SECTION 16 PLANNING APPLICATION NO. A/YL-NSW/357

Further Information Submission

Section 16 Planning Application No. A/YL-NSW/357

Response to Departmental Comments Table

DRAWING TITLE 圖紙名稱
PLANNING PLAN (SHEET 1 OF 2)

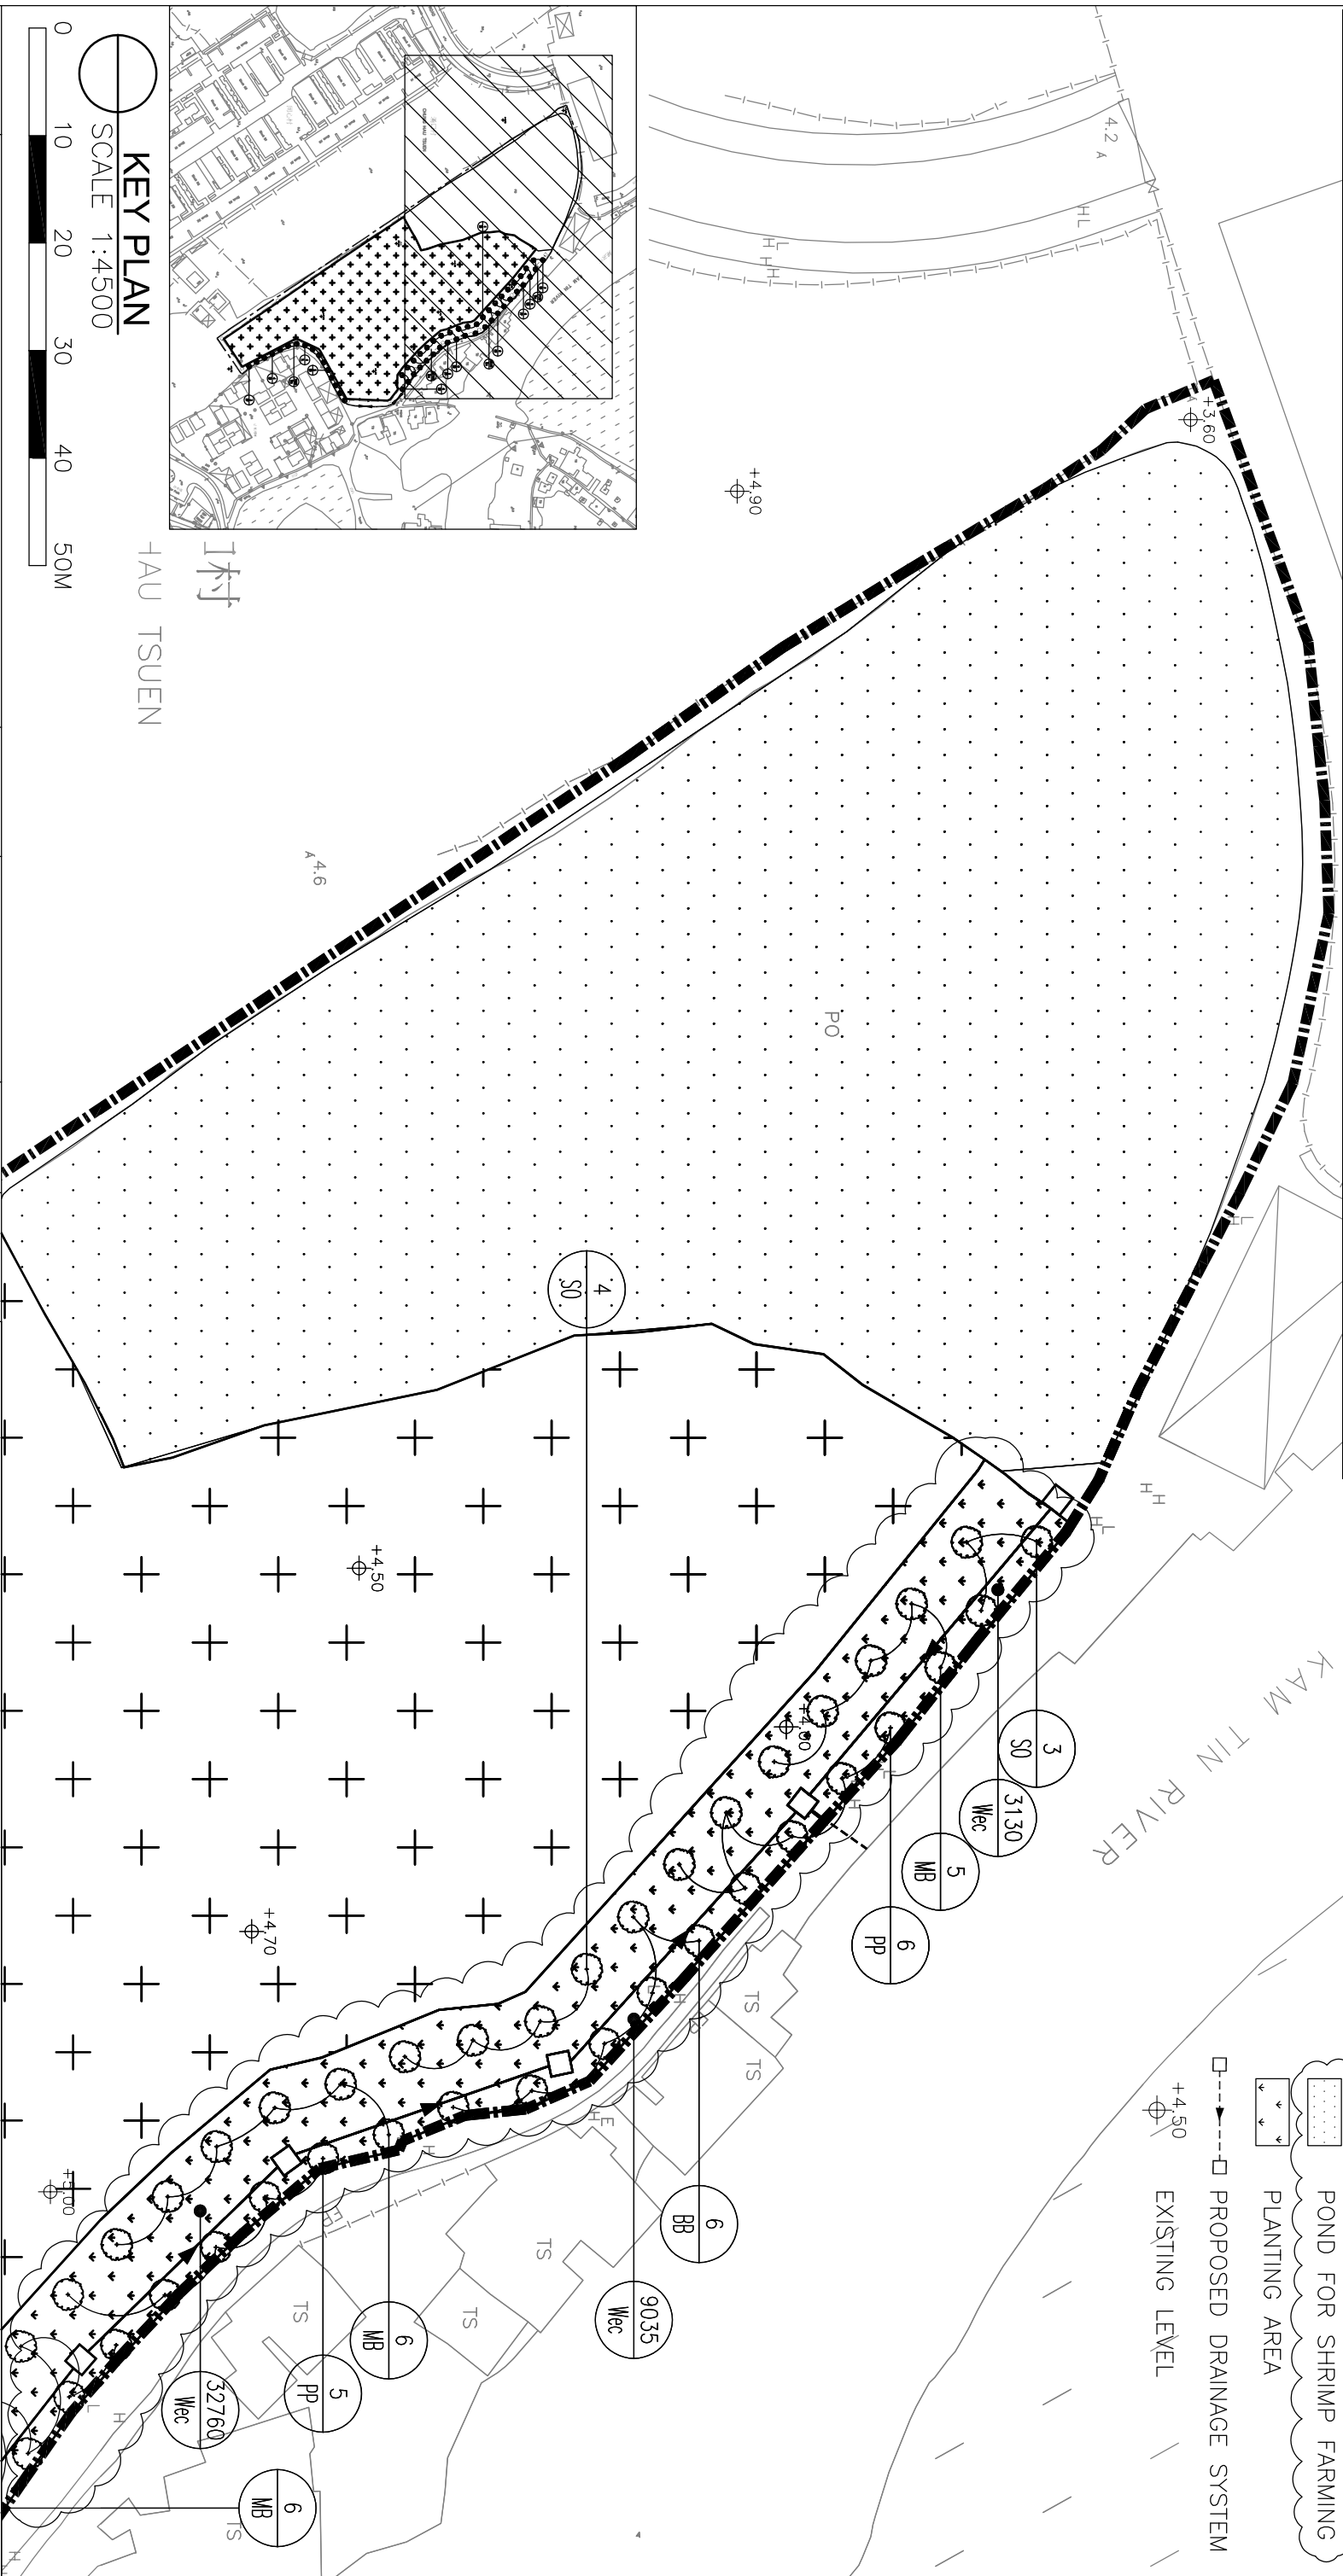
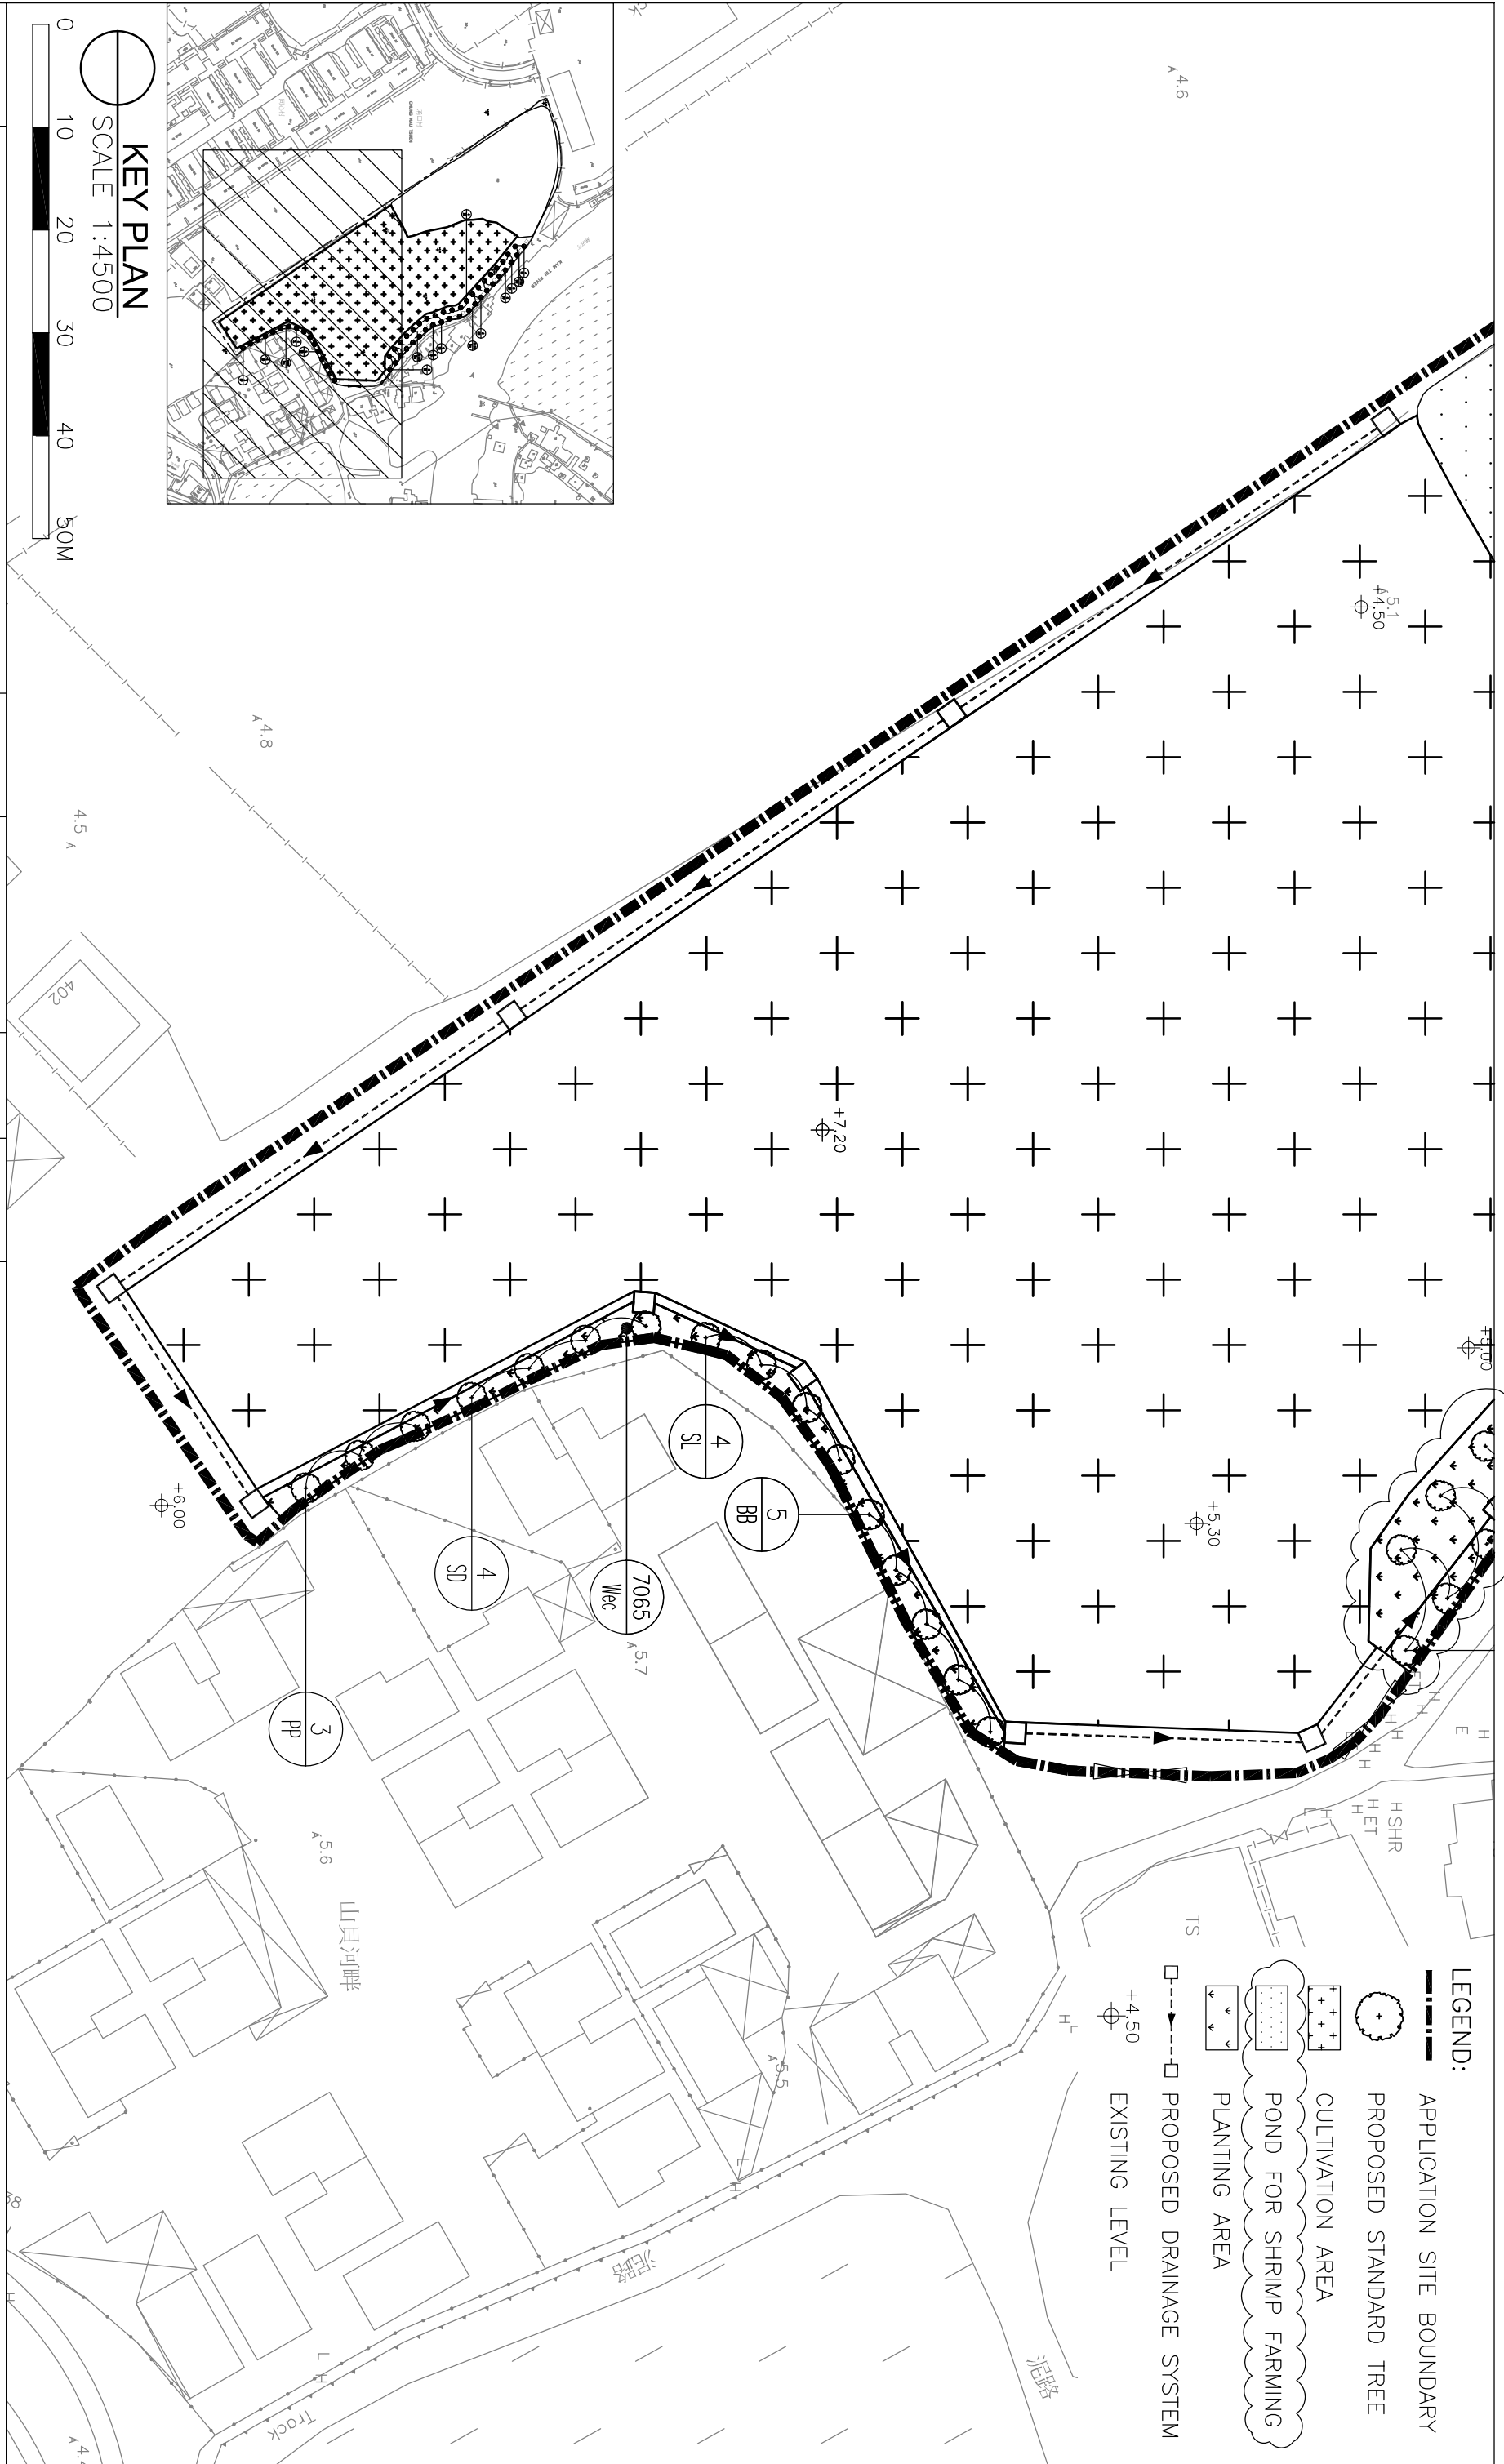
3.	<p>Please consider to plant buffer planting along the entire site boundary facing the old meander of Kam Tin River to minimize disturbance to the wetlands and associated wildlife.</p>	<p>Thanks for your comment. To minimize potential disturbance, the Applicant has further improved the planting proposal. Approximate 10m wide edge planting beds is proposed along the eastern edge while approximate 2m wide edge planting beds is provided along the south edges of the site. Please note the total new tree provision with nos. of 57 is proposed with the approximately 1 : 3.17 compensation ration in terms of quality and quantity of the loss of 18 existing trees, excluding <i>Leucaena leucocephala</i> (銀合歡), in accordance with <i>Processing of Tree Preservation and Removal Proposals for Building Development in Private Projects - Compliance with Tree Preservation Clause under Lease (Guidance Notes of LAO PN No. 6/2023)</i>.</p> <p>Sections 3.5.3-3.5.5 of Planning Statement, Sections 5 and 6, Landscape Master Plan and Landscape Section (Appendix II) and</p>

No.	Comments Received	Our Responses
		Planting Plans (Appendix III) in Tree Preservation and Landscaping Proposal (Annex 5) have been updated respectively.
4.	The construction restriction stated in S.3.4.6 does not tally with other parts of the submission. Please revise.	Section 3.4.6 of Planning Statement has been revised accordingly. Please note that all the construction works will be conducted between tentatively 7a.m. to 5p.m. daytime on any day not being a Sunday or general holiday.
5.	Desktop Review S.5.3.3: Please delete "The exemption of EcoIA for this s.16 planning application has also been considered by the AFCD".	Relevant statement originally in Section 5.3.3 of Planning Statement has been removed accordingly.
